AIR DUCT COVER LOOSE OR MISSING

This Service Information Bulletin (Revision 1) replaces SI B51 02 21 **dated February 2021**.

E-Series	Model Description
F90	M5 Sedan

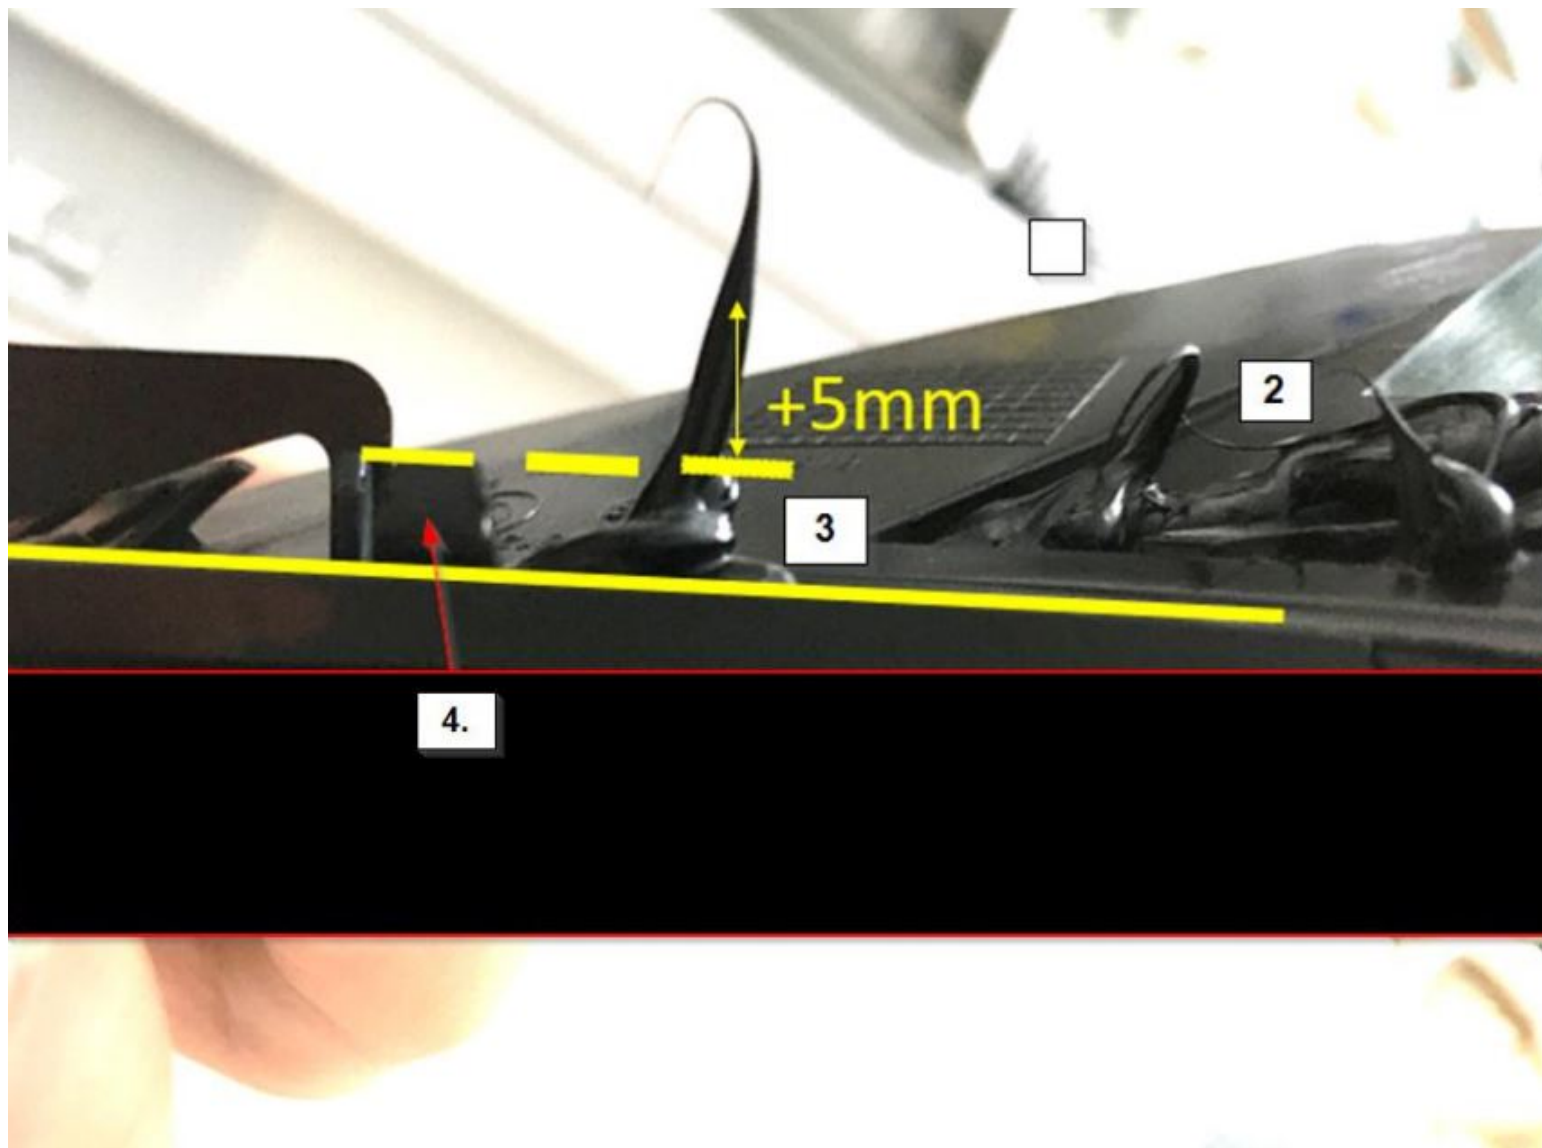
3. Apply window glass adhesive P/N 83 19 2 289 180 to positions 1, 2, and 3 shown below

Note: The adhesive at position 3 will be used to bond the air duct cover to the fender. See step 4 for additional instructions for this position.

4. Ensure the adhesive applied at position 3 is thick enough to extend outwards 5mm beyond the clip(4) shown below. This is to ensure adequate bonding to the fender.
